ALERT SERVICE BULLETIN
REVISION NOTICE
Bell Helicopter**TEXTRON**
A Subsidiary of Textron Inc.

SUBJECT: **REVISION "A" TO ALERT SERVICE BULLETIN 206-06-107:
(VERTICAL FIN SUPPORTS 206-031-417-003/-007 AND 206-031-418-
001/-005, INSPECTION OF)**

NO. 206-06-107

SUBJECT: VERTICAL FIN SUPPORTS 206-031-417-003/-007
AND 206-031-418-001/-005, INSPECTION OF

Figure I: Primer Application for Vertical Fin and Support

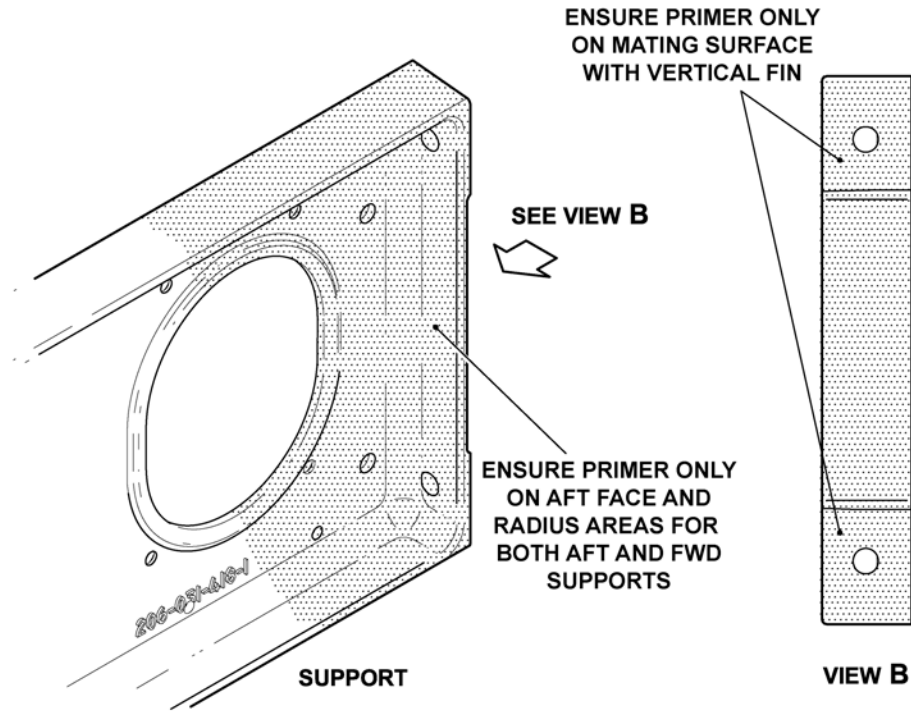
Revision "A" to this bulletin introduces a minimum torque value of 50 in-lbs (5.65 Nm) to be used for the torque check. In addition, the steps from tables 2 and 3 have been re-numbered. As a minimum requirement on the vertical fin, primer only in the area of the mating surface of fin/support, reference revised Figure 1.

6. Inspect the supports and fin for the presence of paint coating at the indicated areas on Figure 1. Do not remove paint now, record your findings and proceed with the step 7 (with Type 2 fin only) and 8 or 9 depending on what you have recorded on Table 2 or 3 as applicable.

- b. Remove all organic finish (primer and paint coating) at the areas indicated on the Figure 1. Reference the BHT-ALL-SPM for paint removal and primer application.

- c. For Type 2 fin only, if incorrect washers (spacers) or no washers were installed, do the following. Perform a visual inspection with a 10 X power magnifying glass of the potted inserts of the vertical fin as per Figure 1, Detail A.

- e. Perform a visual inspection with a 10 X power magnifying glass of the supports in the areas shown on the Figure 1, View B:
 - 1) If no crack is visible, NDT FPI Method (ASTM E1417) may be performed immediately or within the next 100 hours or 3 months following the visual inspection as per the BHT-ALL-SPM. Portable kits (Method C) may be employed for inspection of localized areas of components and parts installed on aircraft. If you choose to accomplish the NDT inspection within the next 100 hours or 3 months, apply two coat of Polyamide Epoxy Primer (C-204) or (C-245) now until the time of NDT. If no crack is present following the NDT, apply two coats of Polyamide Epoxy Primer (C-204) or (C-245) on bare metal surfaces and proceed to step f.

1 If paint is present in this area, it is suspected that the washer (spacer) and mating surface has paint coating. In this case, the fin shall be removed for verification.

This surface shall have primer coating only. Remove all paint coating, if present. Refer to BHT-ALL-SPM.

Figure II: Vertical Fin Type 2 Doubler and Washer (Spacer) Stack-Up Gap Check

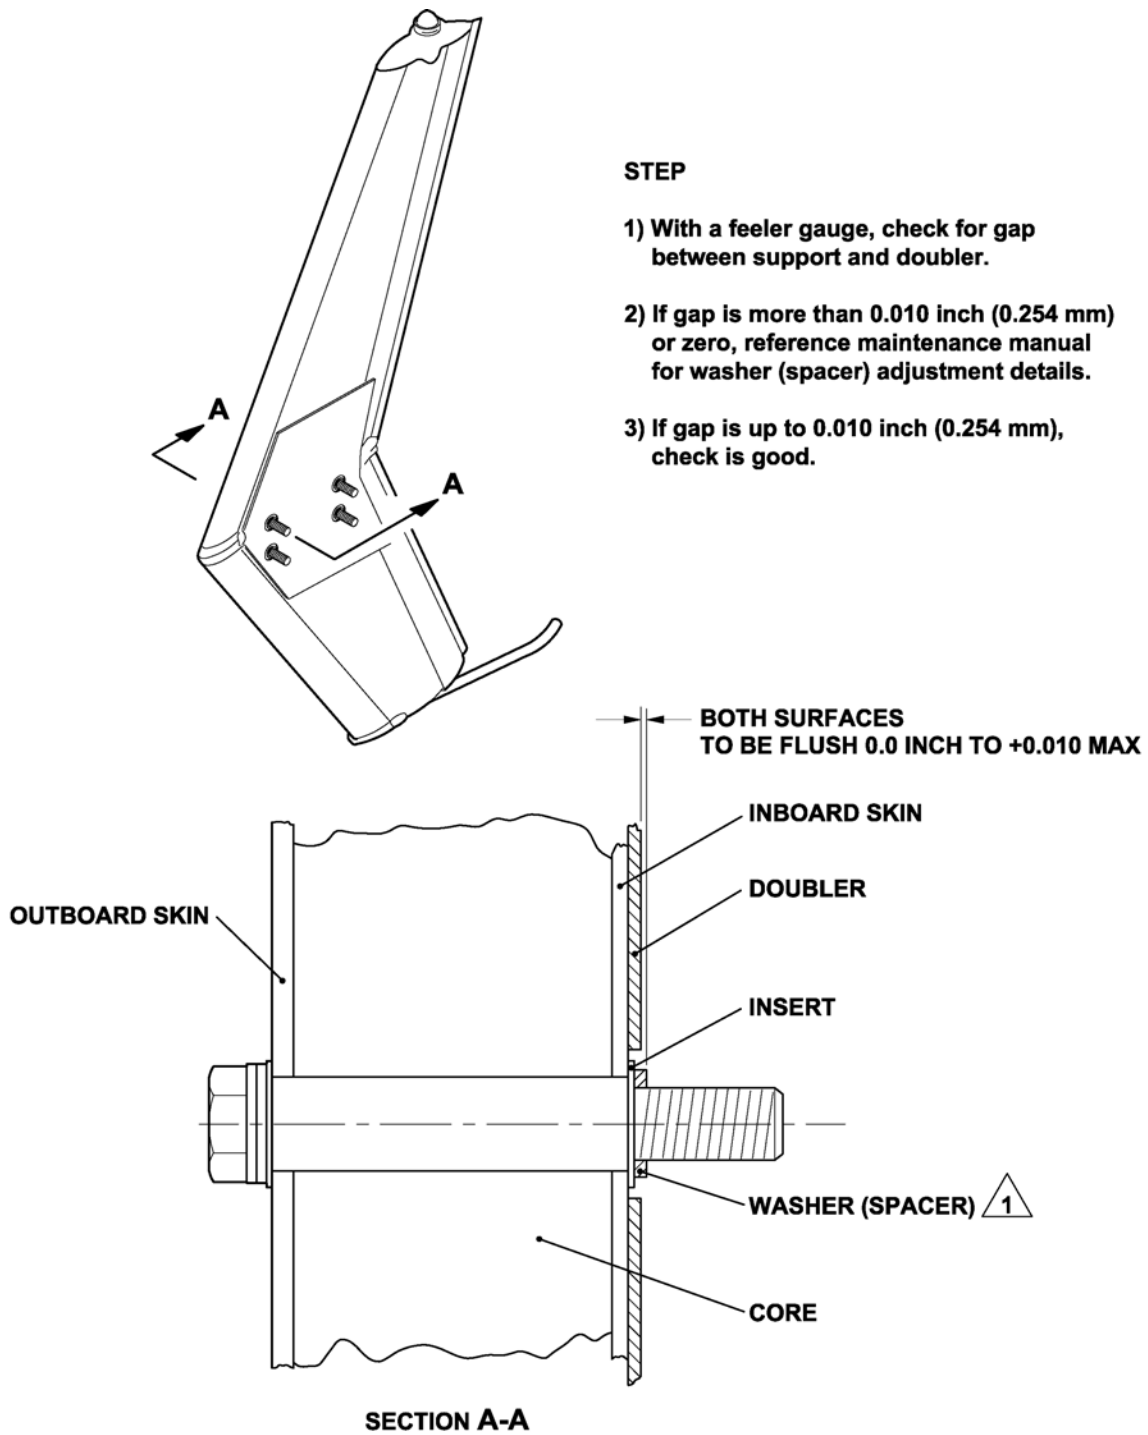
7. Perform gap check. Reference Figure 2. Record your findings and proceed with step 8 or 9 depending on what you have recorded on Table 3.
8. If the torque was within limits (not below 50 in-lbs (5.65 Nm)), no presence of paint and the gap check (Type 2 fin) was good; perform a 10 X visual inspection of the supports in the area of the fin attaching hardware.

- 1) If no damage is found, proceed to step d.
 - 2) If any damage of the potted insert is detected, contact Product Support Engineering.
 - d. If the fin installed is of Type 2, ensure the correct washers (spacers) are installed between the supports and the fin inner skin. Refer to the Figure 2 Section A-A. For washers (spacers) inspection and installation procedure, refer to the BHT-206A/B-SERIES-MM, chapter 53.

1 FOR WASHER (SPACER) INSTALLATION, REFER TO MAINTENANCE MANUAL.
